Item ID: D206-628-013 Accept *N9000040100* Setup Start *NS1*
 Revision ID: Stop *NS2*
 Item Name: Heli-Access-Step LH
 Start Date: 9/24/12 Start Qty: 2.00 *2* Cust Item ID:
 Required Date: 10/12/12 Req'd Qty: 2.00 *2* Customer:
 Reference:

DART SERVICE INSTRUCTION

TO AMEND INSTALLATION INSTRUCTIONS IIN-D206-628 REV. F

A	NEW ISSUE	CP	10.01.29
REV.	DESCRIPTION	BY	DATE
DESIGN	QP	DART AEROSPACE USA, INC PORT HADLOCK, WA	
DRAWN	QP		
CHECKED	3	DRAWING NO.	REV. A
MFG. APPR.	N/A	DSI 9500	SHEET 1 OF 4
APPROVED	H	TITLE	SCALE
DE APPR.	H	MOUNTING LUG CHANGE	NTS
DATE	10.01.29	COPYRIGHT © 2010 BY DART AEROSPACE USA, INC <small>THIS DOCUMENT IS PRIVATE AND CONFIDENTIAL AND IS SUPPLIED ON THE EXPRESS CONDITION THAT IT IS NOT TO BE USED FOR ANY PURPOSE OR COPIED OR COMMUNICATED TO ANY OTHER PERSON WITHOUT WRITTEN PERMISSION FROM DART AEROSPACE USA, INC.</small>

FIGURE 1
D206-628-013 (SHOWN) / -014 (OPPOSITE)
206 A/B FLOAT STEP INSTALLATION

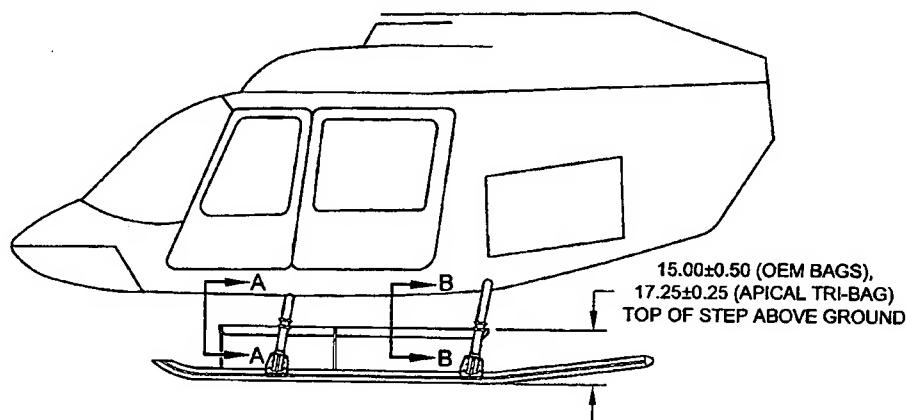
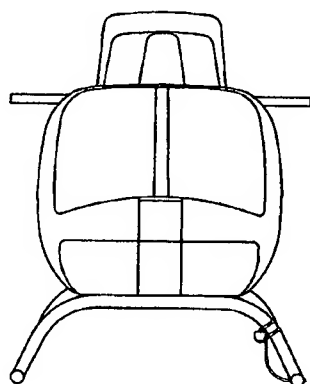
UNMODIFIED D206-628-013/-014 STEP INSTALLATIONS AT CHANGE 005 (OR EARLIER) WILL NOT INSTALL AT THE 18.50" HEIGHT REQUIRED FOR COMPATIBILITY WITH APICAL TRI-BAG FLOATS.

D206-628-013/-014 STEP INSTALLATIONS AT CHANGE 006 (OR LATER) CONTAIN NEW MOUNTING LUGS FOR COMPATIBILITY WITH APICAL FLOATS.

CONTRARY TO INSTALLATION INSTRUCTIONS IIN-D206-628, FOR COMPATIBILITY WITH APICAL TRI-BAG FLOATS, THE D206-628-013/-014 STEP INSTALLATIONS SHOULD BE INSTALLED AT A HEIGHT OF 17.25" PER FIGURE 1 OF THIS SERVICE INSTRUCTION.

WHEN INSTALLING THE MOUNTING LUGS, IT IS ACCEPTABLE TO USE LONGER/SHORTER AN4C BOLTS AS REQUIRED AND/OR INSTALL EXTRA AN960C416/416L WASHERS UNDER THE BOLT HEADS TO ENSURE 1.5 TO 4 THREADS IN SAFETY.
